DOCUMENT 00 90 00
ADDENDUM

ADDENDUM No.: 1

DATE: September 19, 2024

RE: VIROQUA HOUSING AUTHORITY
PUBLIC HOUSING PROJECT WI 118
200 PARK VIEW COURT
VIROQUA, WI 54665
PROJECT NO. 24012

DEMOLITION PLAN (ALTERNATE BID)

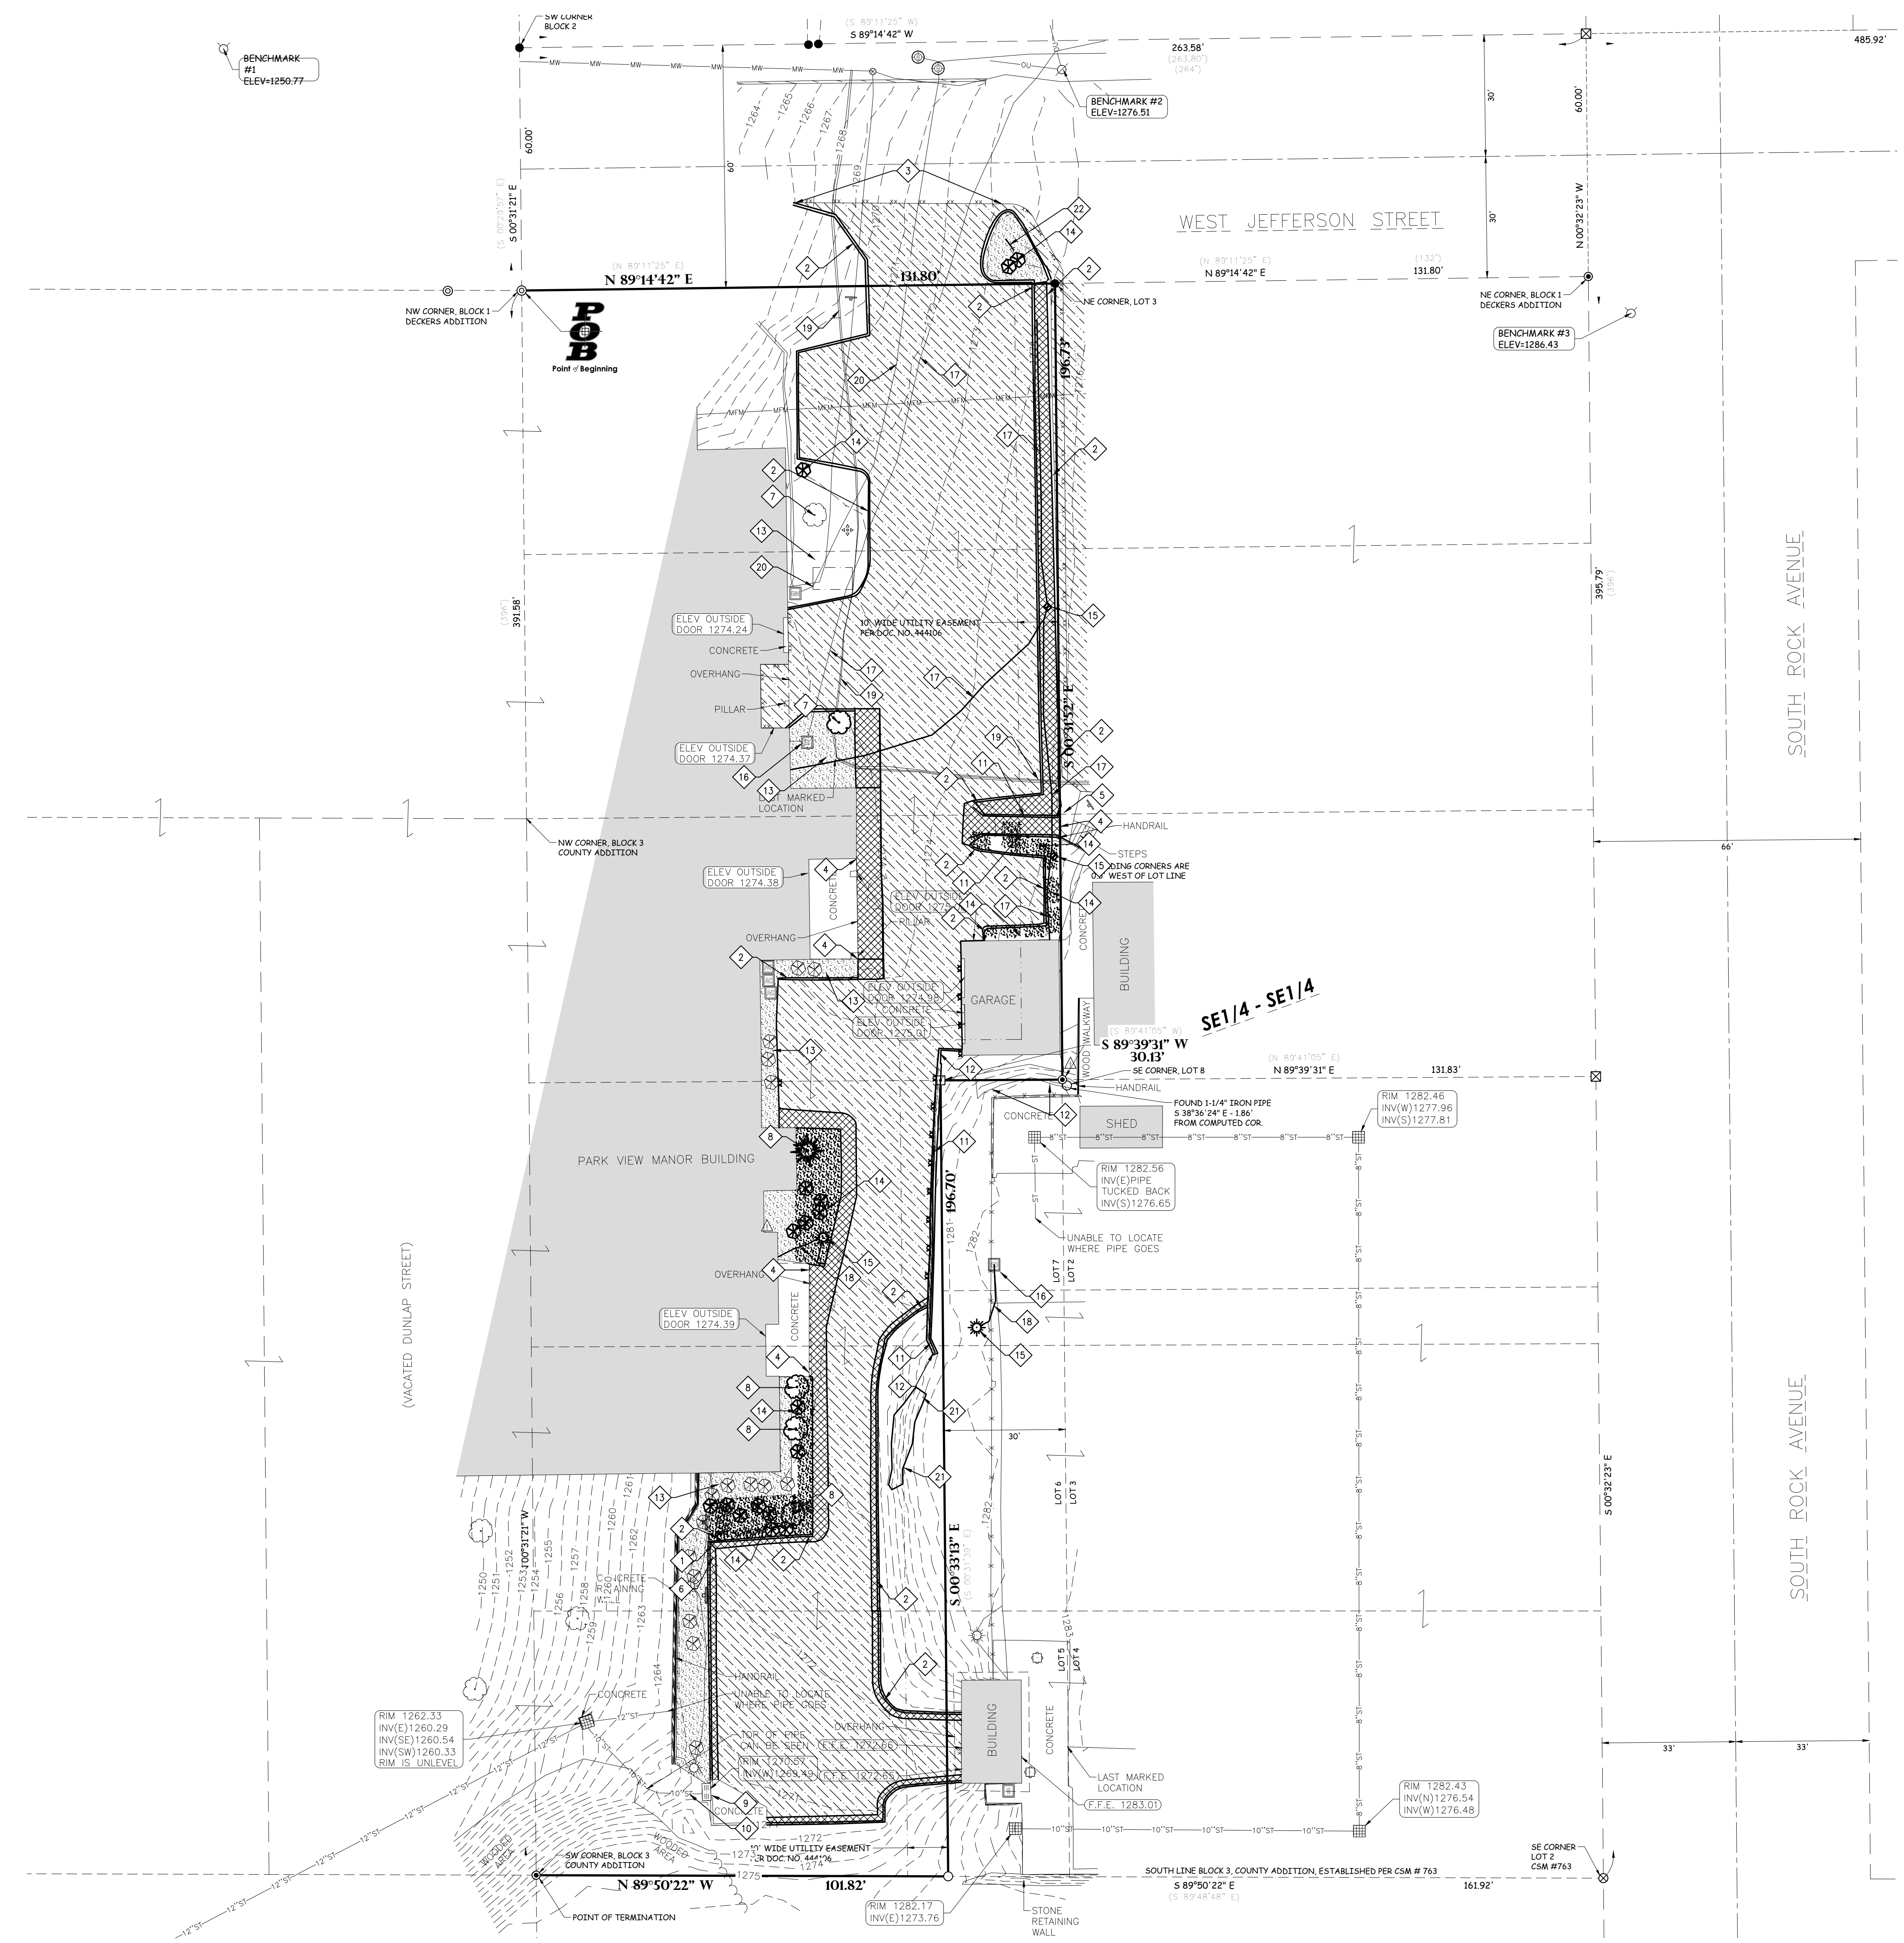
7. Sheet C100 DEMOLITION PLAN (ALTERNATE BID) 30"x42"
 - a. See the revised sheet included in this addendum. Disregard the previous version.
 - b. See new general note 13 regarding maintaining access to east side building entrances.

C200

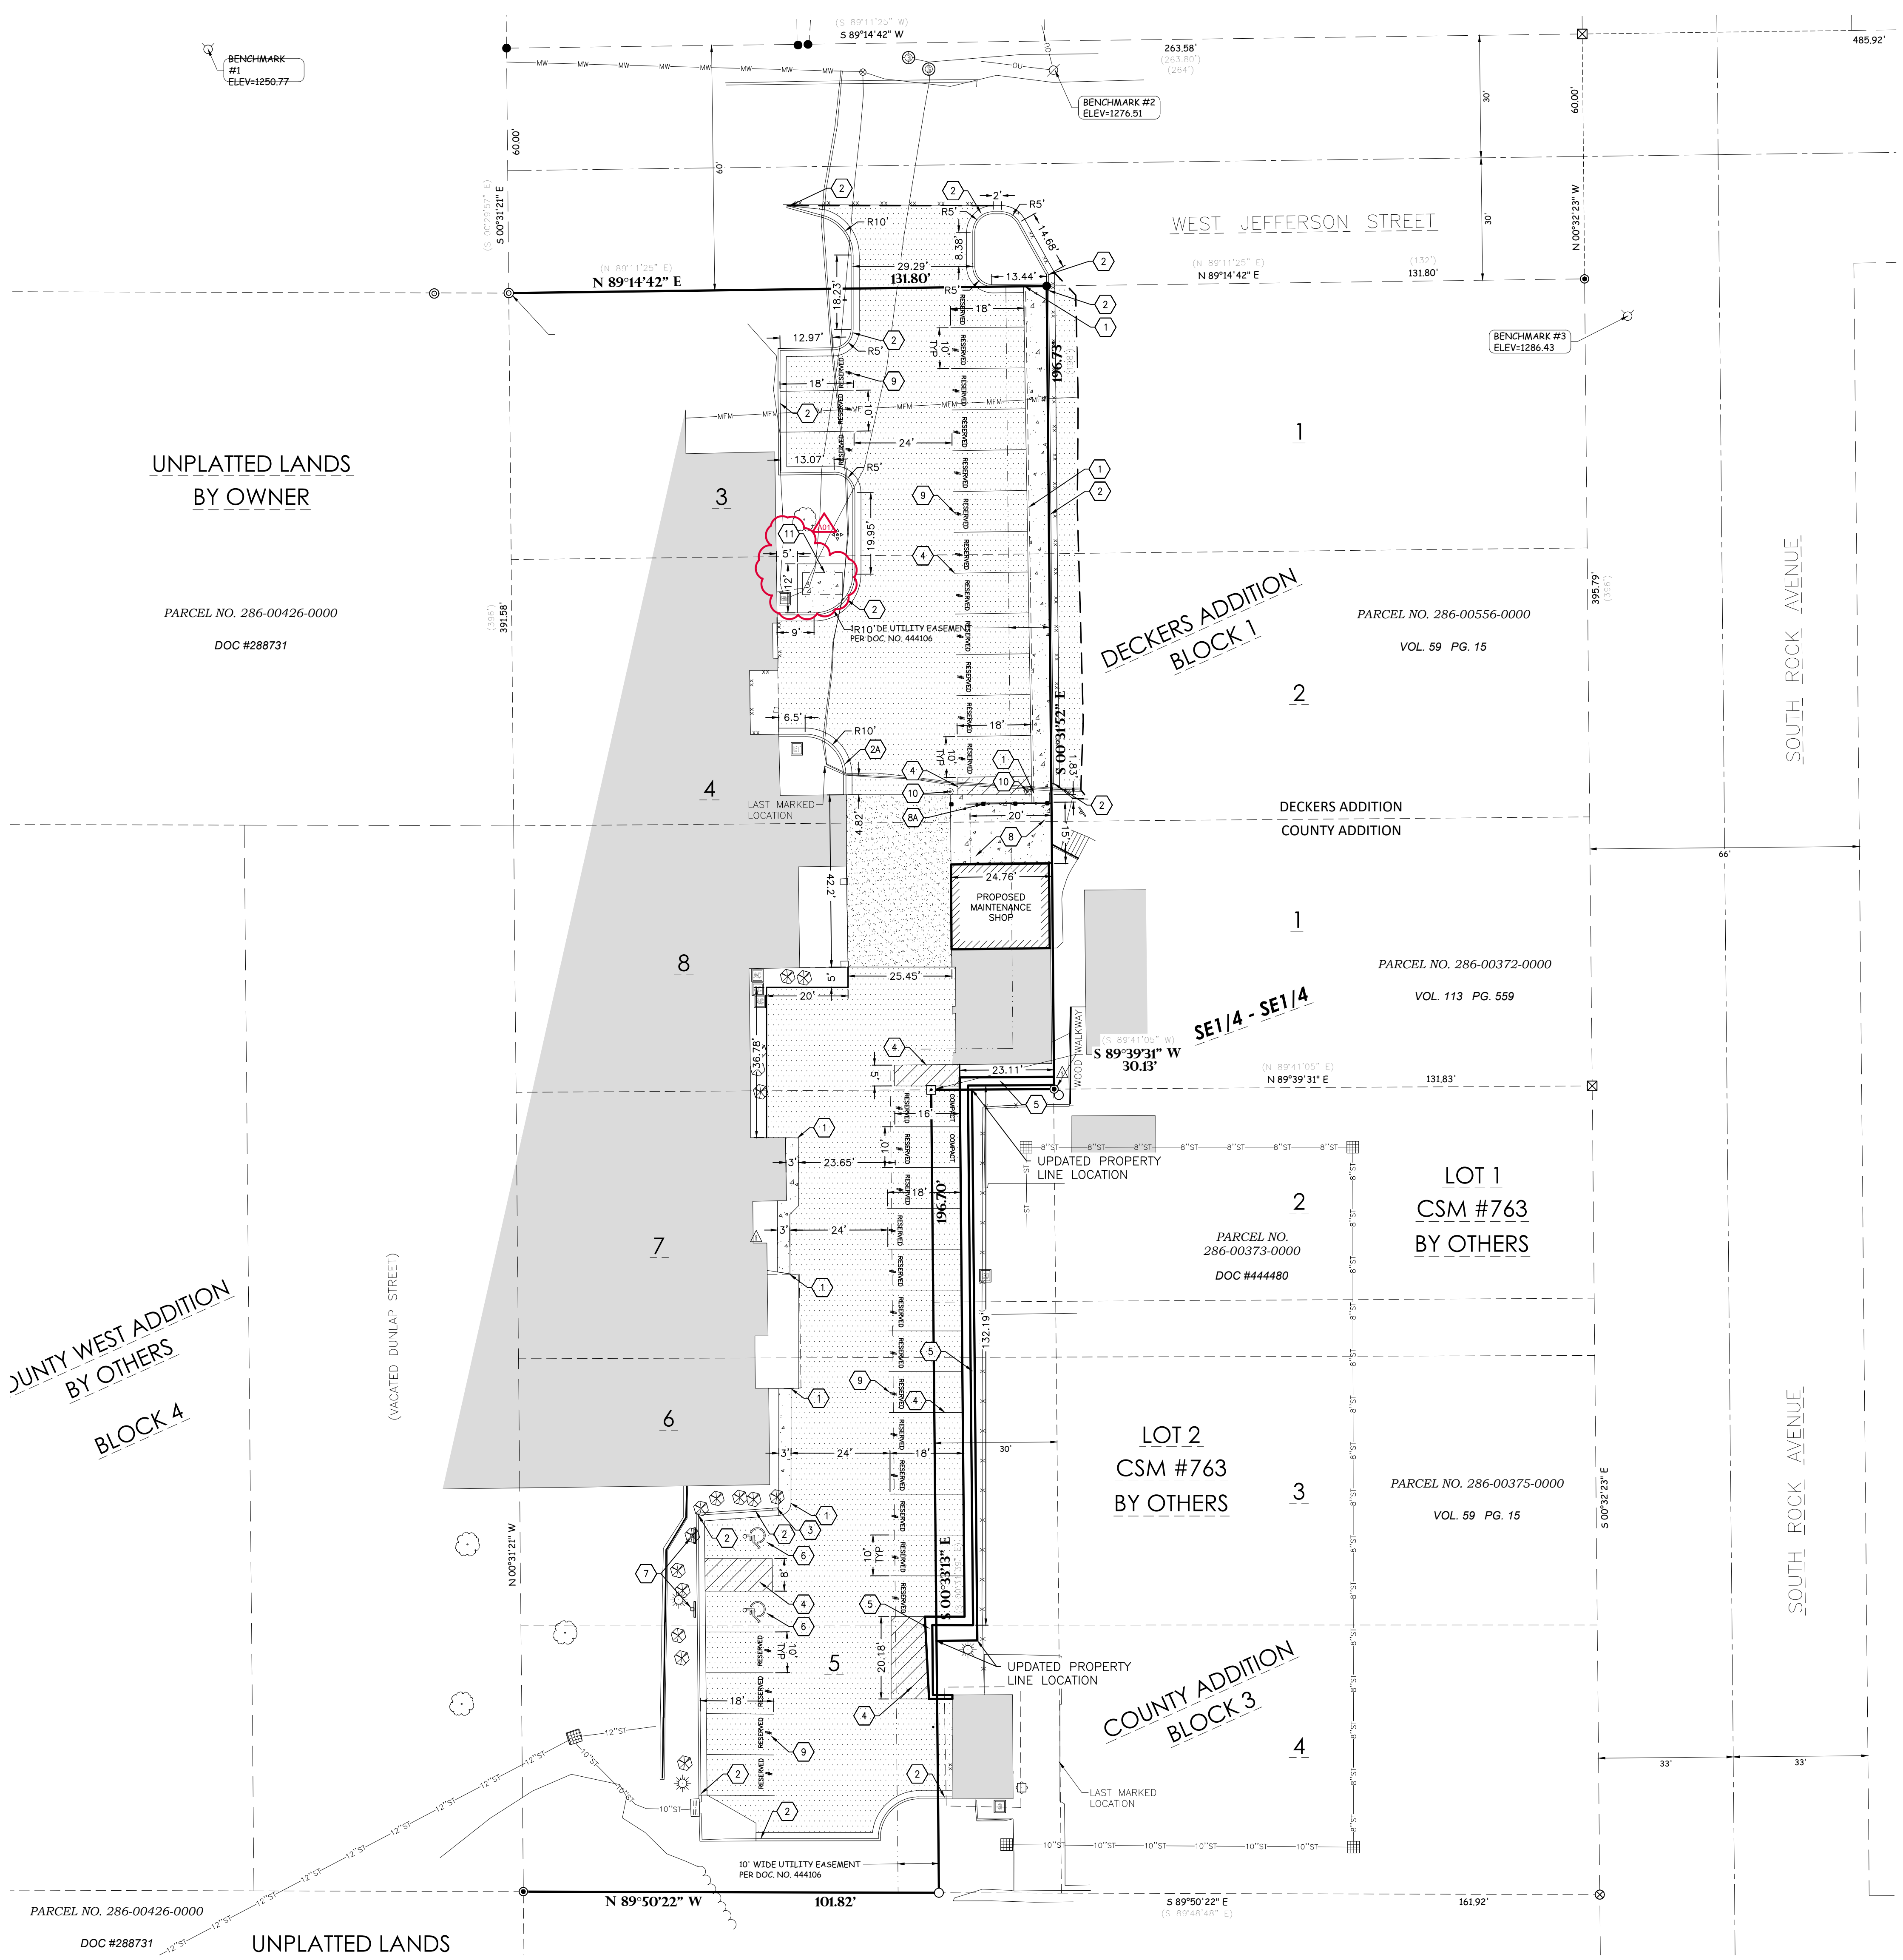
8. Sheet C200 LAYOUT PLAN (ALTERNATE BID) 30"x42"
 - a. See the revised sheet included in this addendum. Disregard the previous version.
 - b. See added concrete pad.

- c. See new general note 13 regarding maintaining access to east side building entrances.
9. Sheet C300 GRADING PLAN (ALTERNATE BID) 30"x42"
 - a. See the revised sheet included in this addendum. Disregard the previous version.

C300

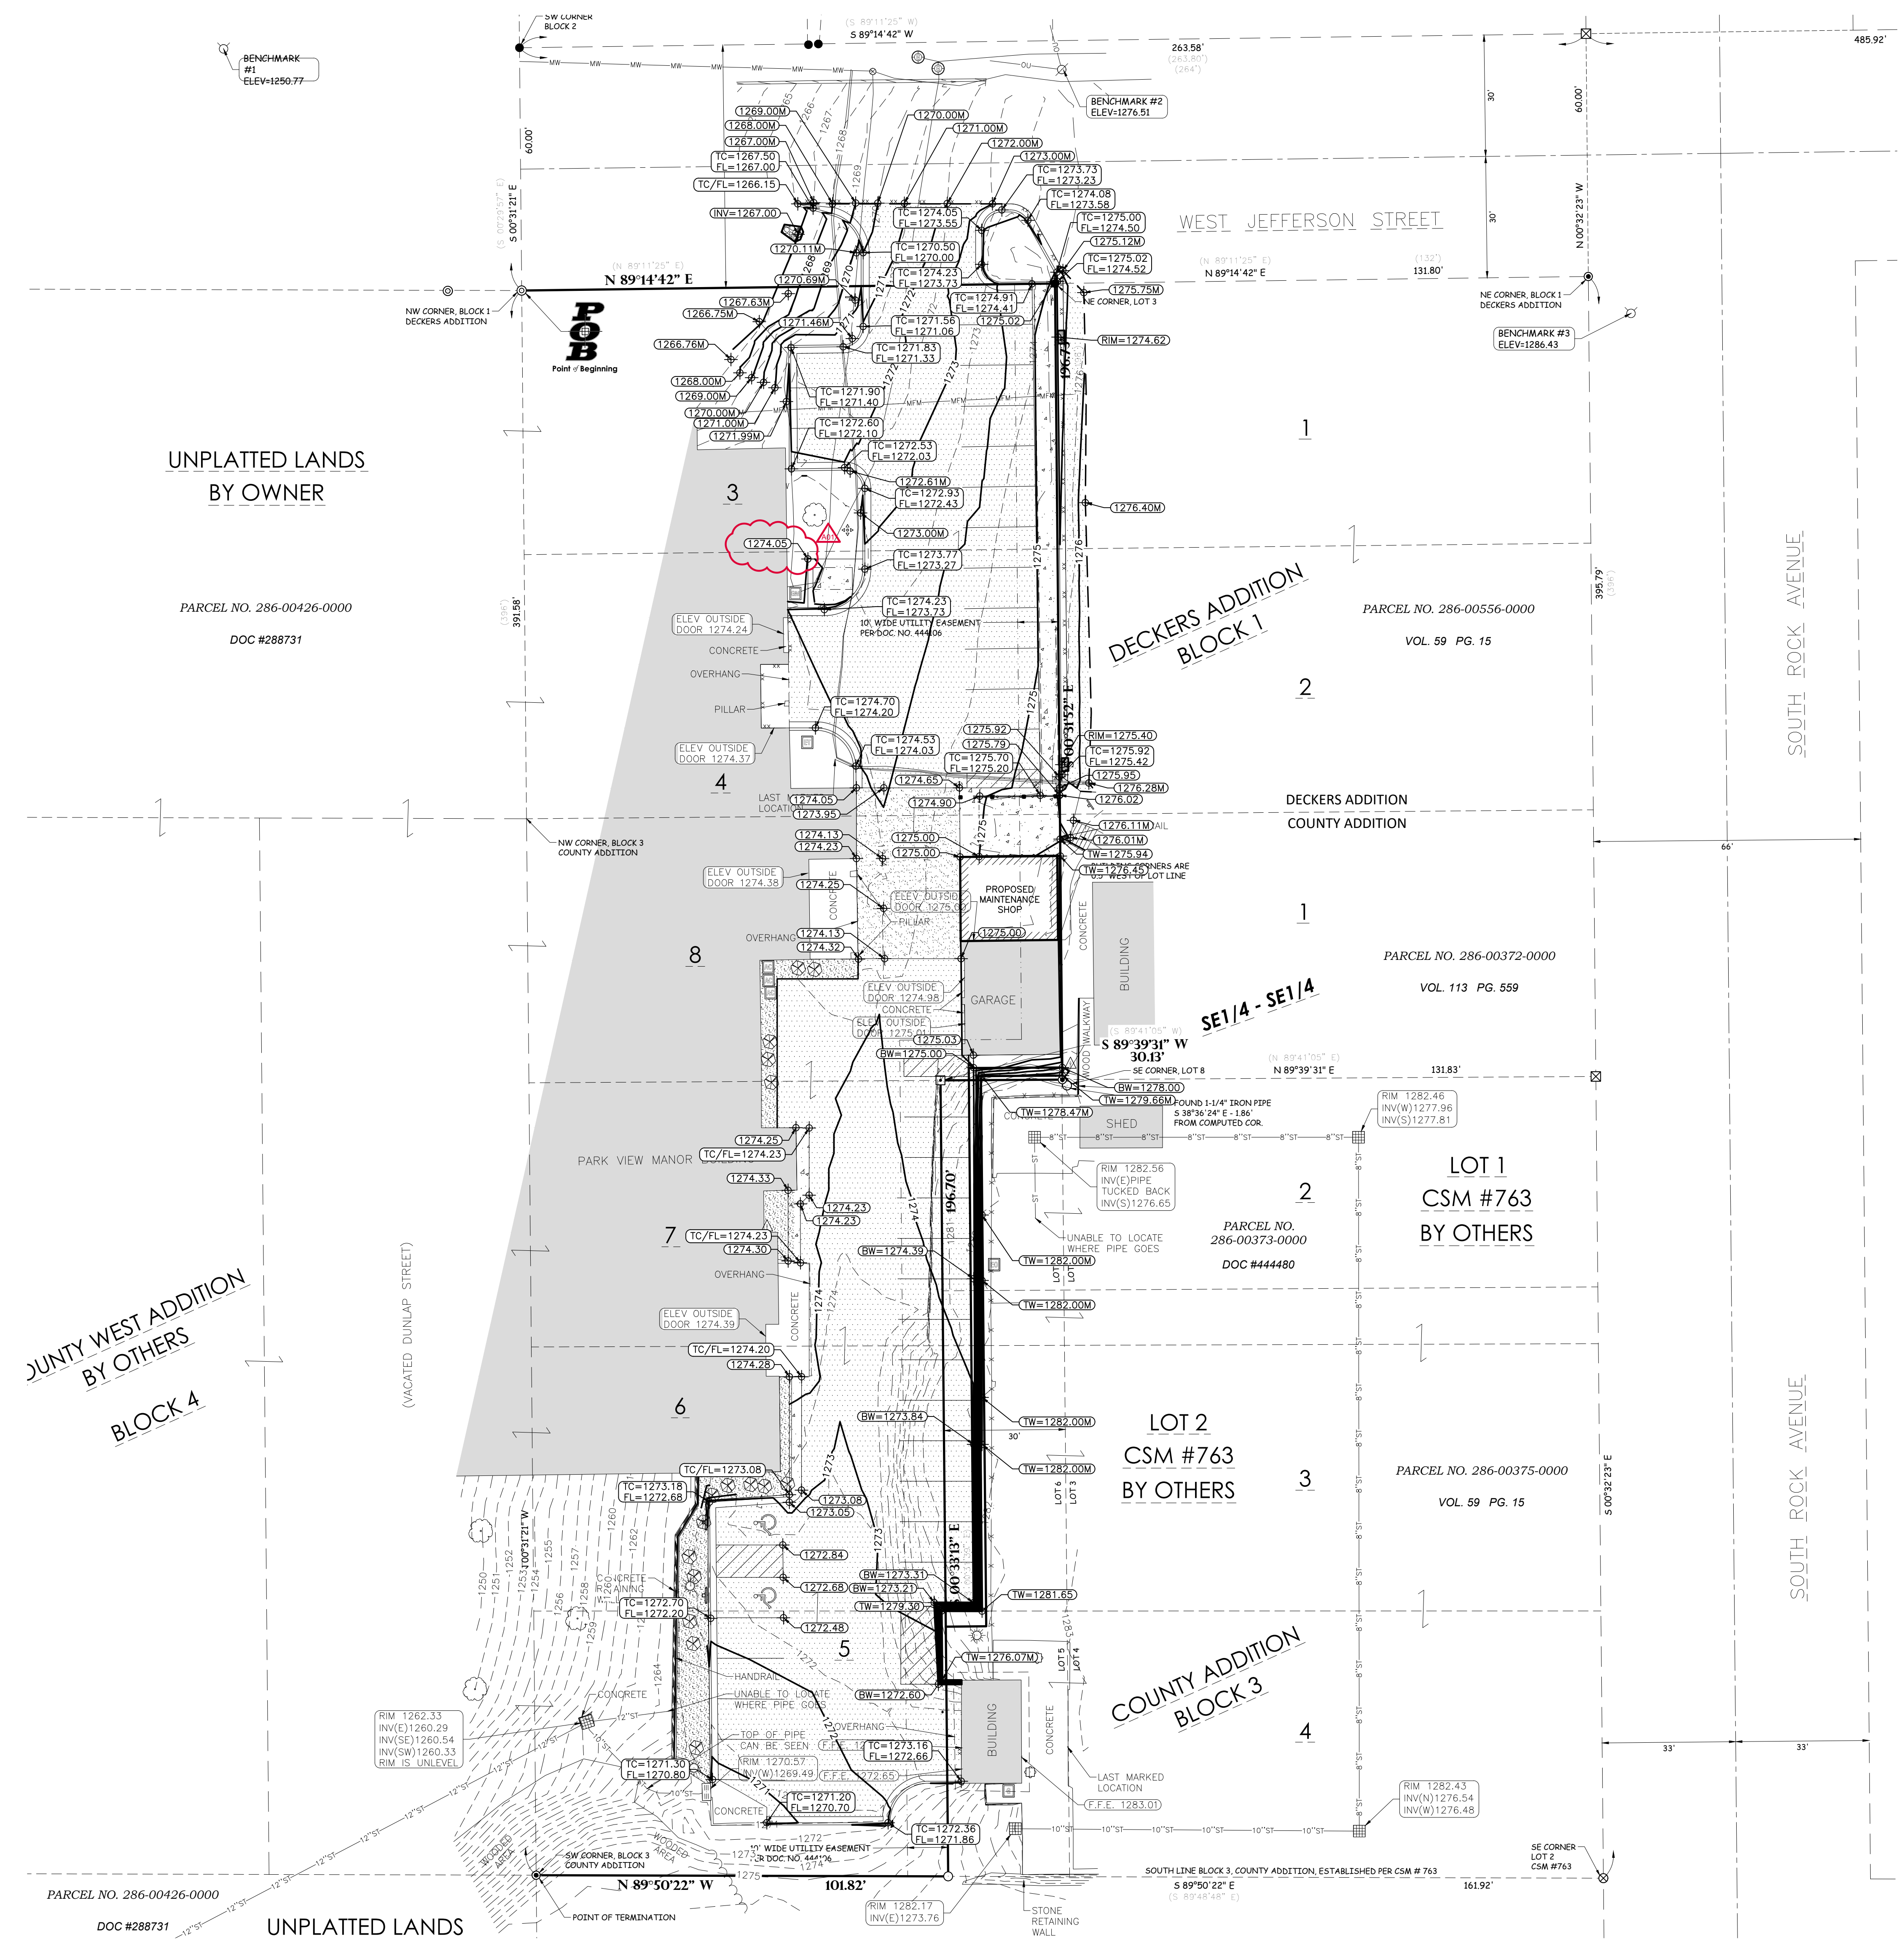
- b. See added concrete pad and keynote 11.
 - c. See new general note 13 regarding maintaining access to east side building entrances.
10. Sheet A101 THIRD FLOOR 30"x42"
